WATER PERMIT NO. 8417-3

**SOUTH DAKOTA
WATER PERMIT NO. 8417-3**

RIVER FARMS POND (378)
PLAN VIEW
Charles Mix County, South Dakota

Plan & Specification Review

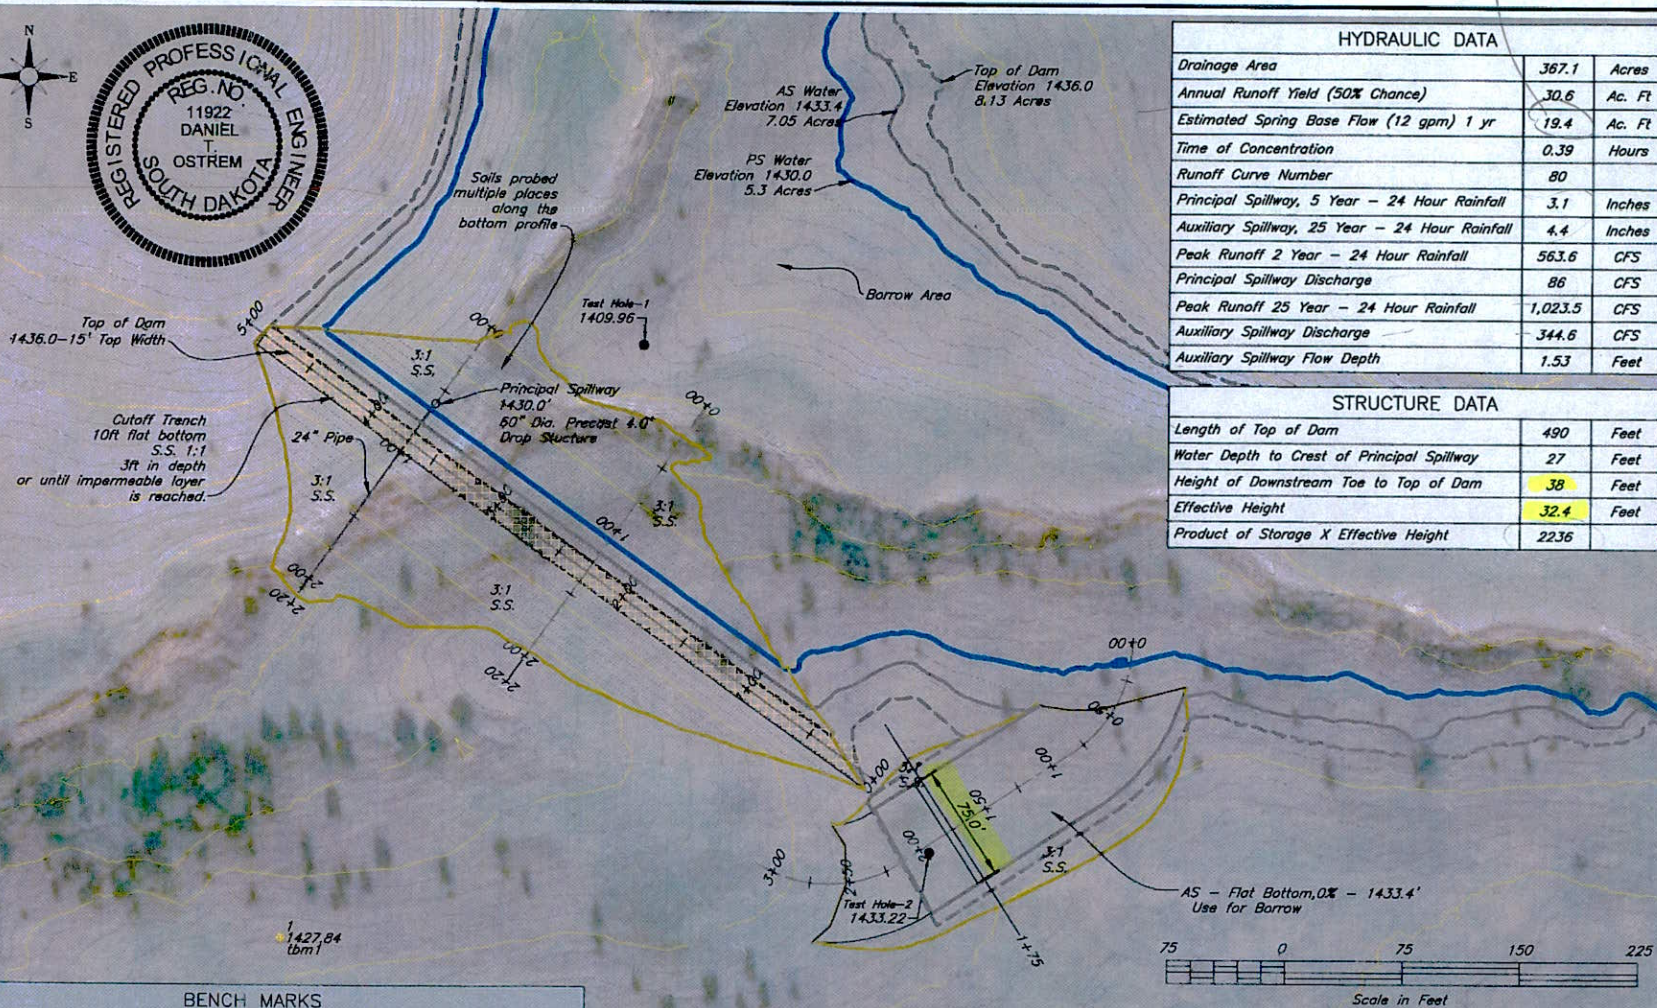
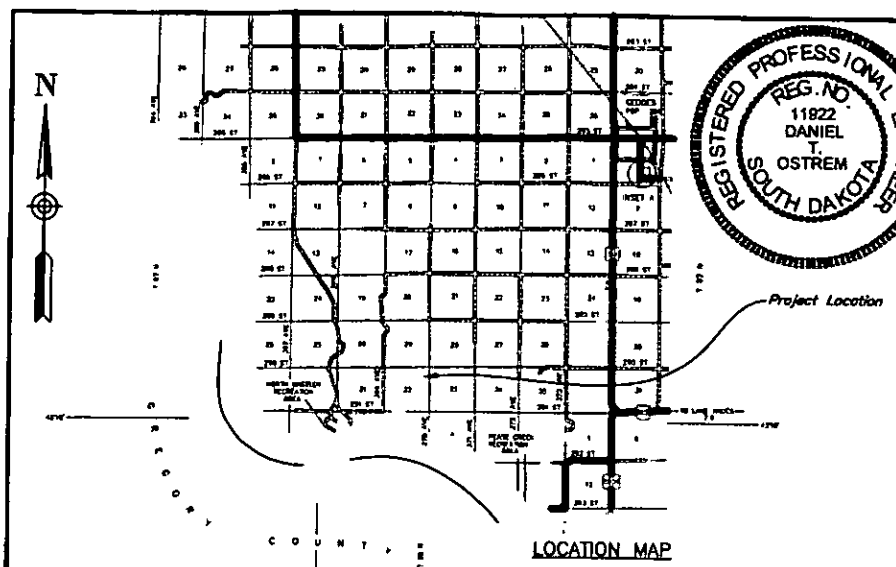
- see attached graph made from
3 pts of pool data given on Sheet 2 of 8

- auxiliary spillway dimension from sheet 3 of 8
- slope dimensions from sheet 4 of 8
- spillway Discharge = 344.6 cfs sheet 2 of 8

If $H = 1.53 \text{ ft}$ (as per sheet 2 of 8) and the max value of n is used (0.033) then $Q = 350.32 \text{ cfs}$

RIVER FARMS
POND (378)
PIPE DROP STRUCTURE

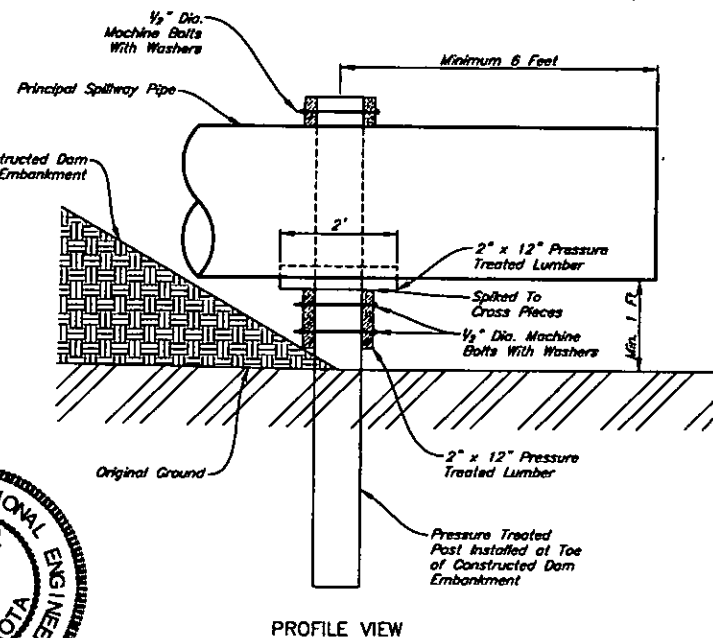
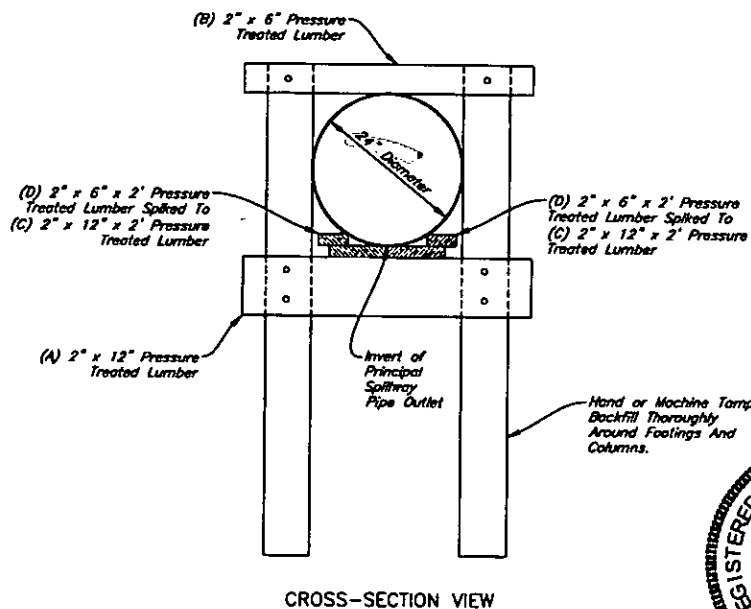
I am helping one of the newer Water Rights engineers work through the P&S review on Review Farms. Since there was not a detail on the elbow in the principal spillway, we wanted to ask for some more information on how that elbow joint is going to be done. We have some slight concern that the transition at that elbow is somewhat abrupt and might result in an area of the principal spillway conduit more prone to failure. So we just wanted to ask for some more information on how the elbow joint is going to be done or check if the transition was looked at in the design work and determined to not be a concern.

I designed it with the lowest angle listed above. Our NRCS standards require a 5% or less outlet slope for a 24" pipe. I started with the 5% outlet and added in the bend angle. You then slide this combined pipe angle back along the 5% pipe until it reaches your PS inlet structure. This method (in my opinion) gives you the best geometry with the least amount of deflection. It does however require you to cut the pipe on the downstream sections. The alternative is to try and place the bend after a set number of pipe sections to avoid the cut. Doing this, you will need to bring the outlet pipe up to less than 5% grade in order to still be able to have your pipe be at an angle that hits your inlet structure the way you need it to.

Now to answer your question about failure, I'm not too worried about the "abrupt" angle. The pipe will almost never be under 100% full pipe flow pressure. Pipe failures start from water flowing along the outside of the pipe, either through the soil fill or from leaking pipe joints. Care in construction makes all the difference here. Good joints and a properly installed sand diaphragm will make all the difference in the success of this principal spillway.
